# UNITED STATES PATENT AND TRADEMARK OFFICE

APPLICATION NO.	FILING DATE	FIRST NAMED INVENTOR	ATTORNEY DOCKET NO.	CONFIRMATION NO.
10/519,116	08/10/2005	Mark Bigley	4990-106 US	9475

<b>Office Action Summary</b>	<b>Application No.</b> 10/519,116	<b>Applicant(s)</b> BIGLEY ET AL.	
	<b>Examiner</b> Marcus Menezes	<b>Art Unit</b> 3677

## DETAILED ACTION

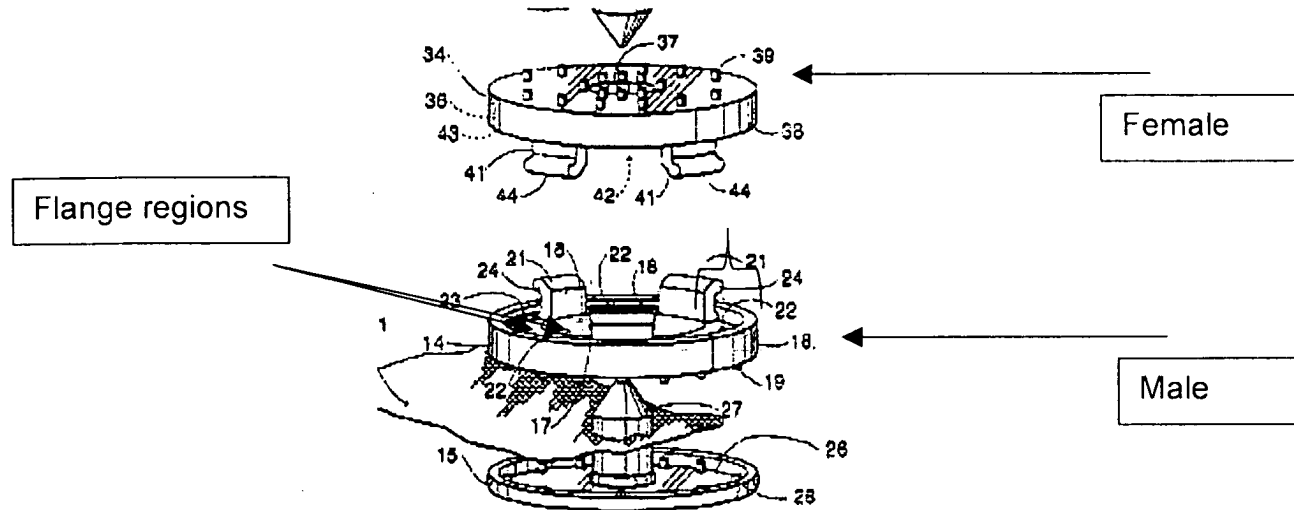
Lyle discloses a male stud of a snap fastener comprising a male portion (18,21) for cooperating with a female portion in use, the male portion comprising a continuous radially protruding flange (16) with a front face that in use engages said female portion (see figure 2 for engagement); said flange having regions of greater and lesser radial protrusion circumferentially spaced therein thereby to enable the proportion of the outer circumference of the flange front face that abuts said female portion in use to be predetermined. (See figure below).

Lyle further discloses a male stud of a snap fastener, for cooperating with a female stud in use, said male stud having a flange portion (16) and a male portion (18,21), said male portion comprising a plurality of circumferentially extending engaging portions (21), each engaging portion being separated from the next engaging portion by a circumferentially extending non-engaging portion (22, and the areas in between the engaging portions 21); wherein the combination of engaging and non engaging portions provide a cylindrical or annular shaped wall that extends from said flange.

Lyle further discloses that at least one engaging portion extends radially outwards, that the engaging portion is arcuate in shape and that the non engaging portion comprises a flat face (22) and an arcuate-shaped recess (area in between said engaging portions). Also disclosed is an attaching means comprising a rivet or post member (27).
